## Service Bulletin

### Announcement of DX-D 100 System Version 4

<b>Title:</b>	DX-D 100 - Service Bulletin No. 19 - Announcement of released DX-D 100 Version 4.0
<b>Livelink ID:</b>	38648378
<b>Version#:</b>	16
<b>Version Date:</b>	2013/01/23 01:16 PM CET
<b>Status:</b>	Approved on 2013/01/25 08:05 AM CET
<b>Owner:</b>	Beate Richter (axnwp)
<b>Created By:</b>	Beate Richter (axnwp)
<b>Created Date:</b>	2012/10/26 12:57 PM CET
<b>PDF Creation Date:</b>	2013/01/25 08:07 AM CET

Figure 5

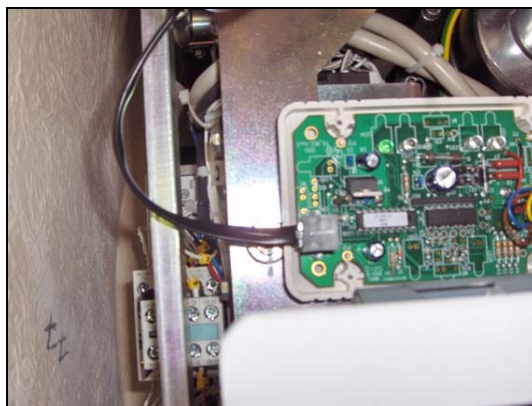
- (2) Remove the rear cover (pay attention to the 2 wires + the infrared communication cable)  
See following 3 figures.

Figure 7

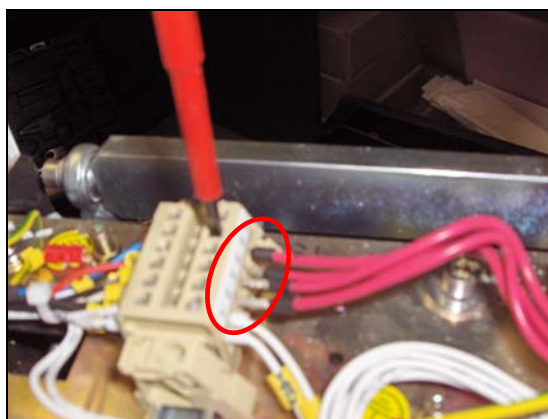
- (3) Disconnect the red wires and two white connectors.

Figure 8

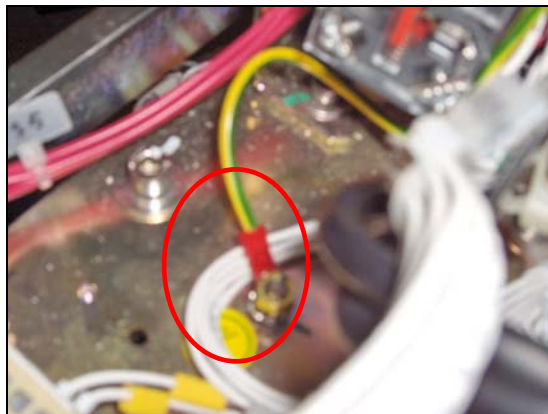
- (4) Disconnect earth connection.

Figure 10

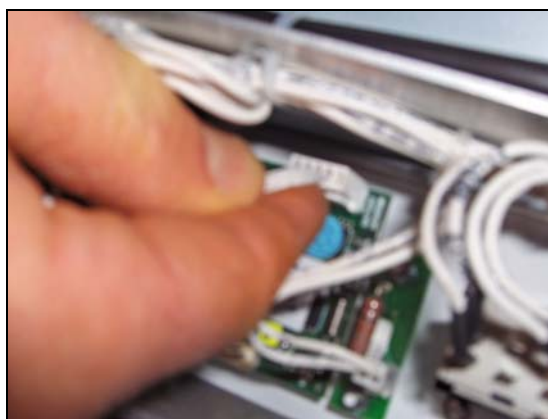
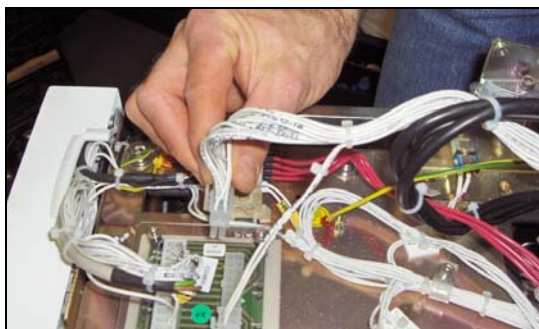
- (6) Remove 4-pin and 5-pin connectors from the screen assembly.  
See following two figures.

Figure 12

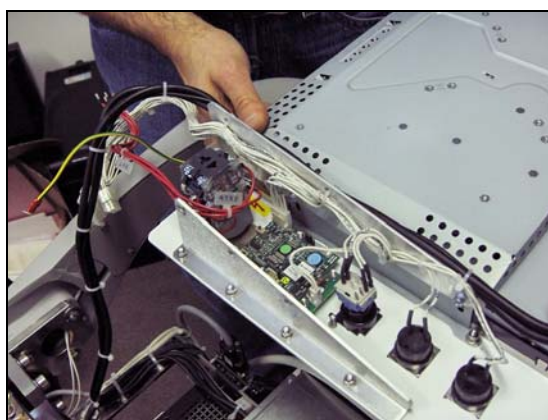
- (7) Assembly is now loose and can be dismantled.

Figure 14

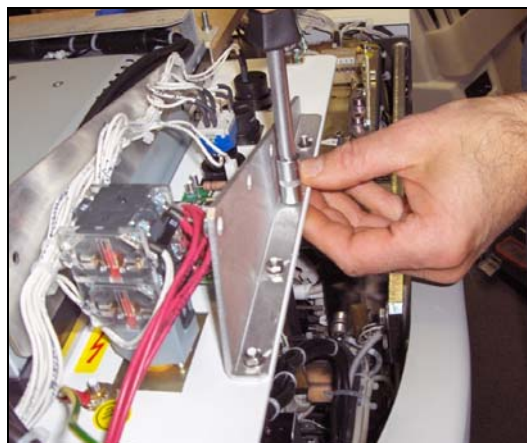
- (8) Remove the two side protection plates (8 bolts each side). See the following two figures.

Figure 15

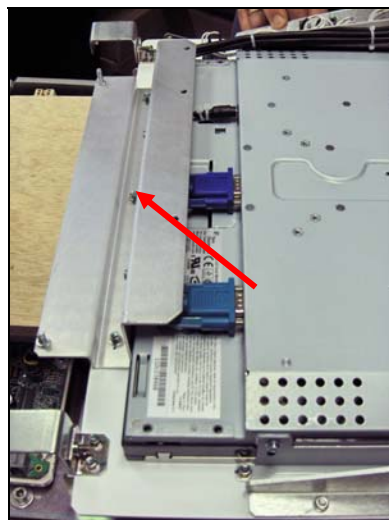
- (9) Remove the cable protection plate.  
See the following three figures.

Figure 17

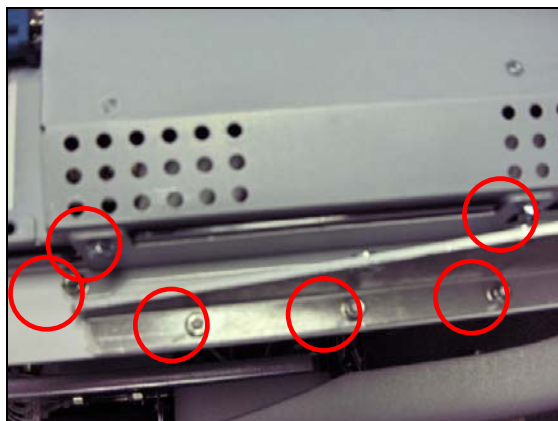
- (11) Remove 6 screws.

Figure 19

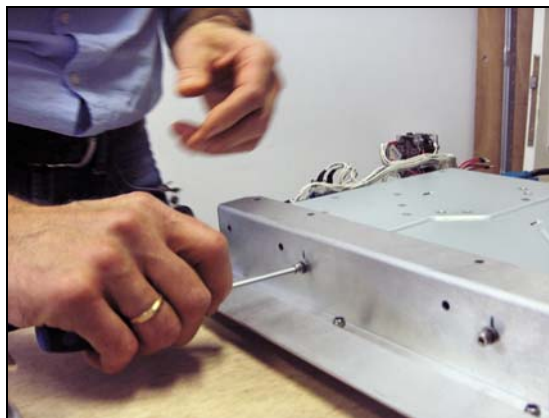
- (13) If this is not possible, remove cable protection and re-assemble to allow enough slack).

Figure 21

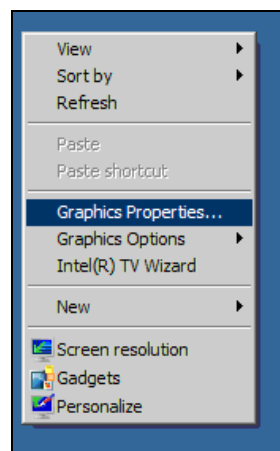
- (17) On the Windows desktop, right-click on **<Graphics properties>**.

Figure 22

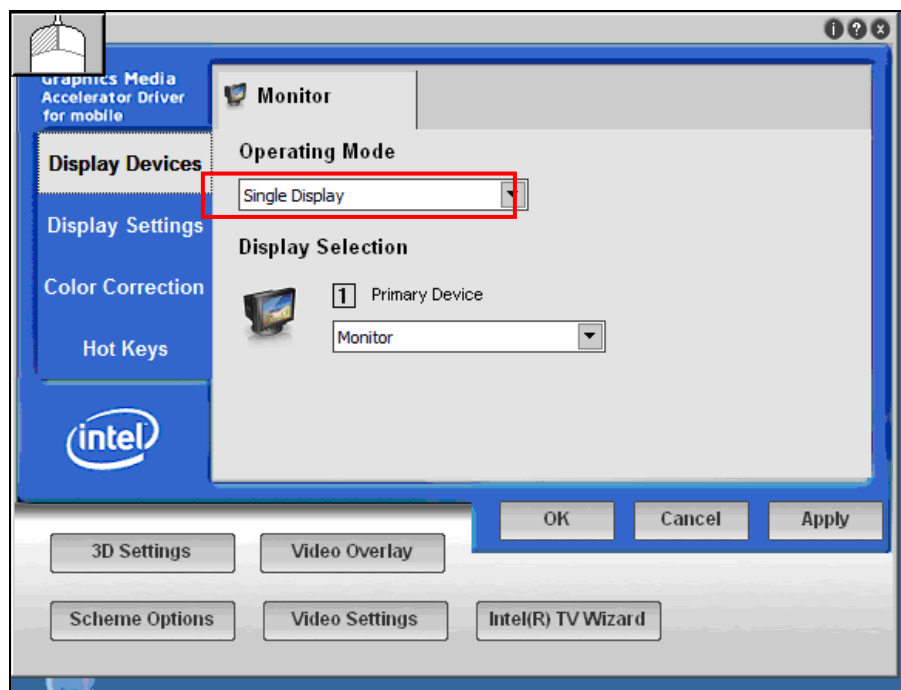
- (18) In **<Display Devices>**, select **<Single Display>** (see figure below).

Figure 23

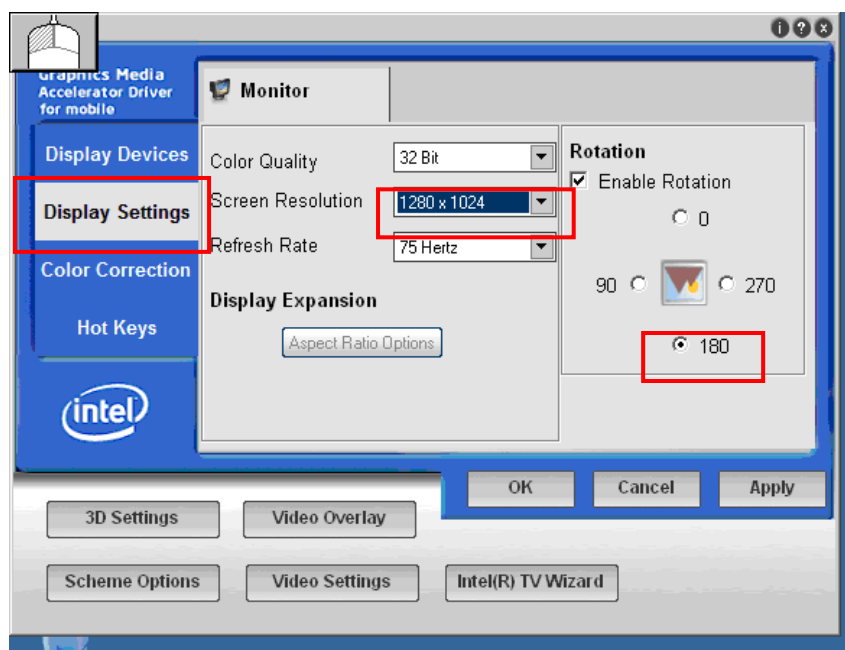
- (19) In <Display Settings>, select <Screen Resolution> 1280x1024.
- (20) Set <Rotation> to "180".
- (21) Click <Apply> and <OK>. The screen will rotate.
- (22) Confirm the new settings.

Use the <Enter> key to confirm the new settings, since the monitor is flipped and touchscreen calibration needs to be performed again.

Figure 24

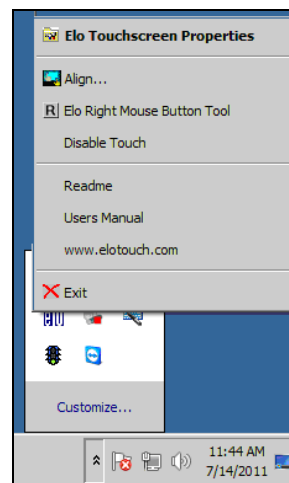
This action must always be followed by a touchscreen calibration procedure, see next step:

- (23) Click on the ELO icon in the lower right taskbar of the screen; see figure 2.
- (24) Click: <Align>
- (25) Follow the instructions on the screen.

Figure 25

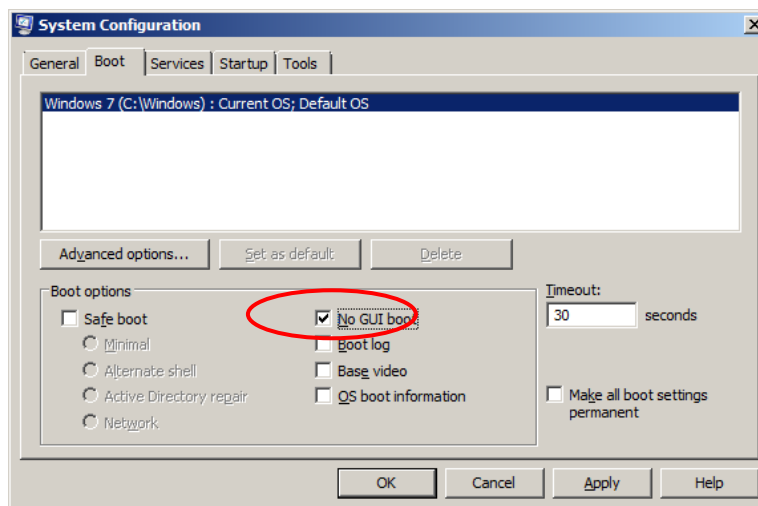
- (1) Type 'msconfig' into the start menu search box.
- (2) Go to the <Boot> tab in msconfig and check <no GUI boot>.
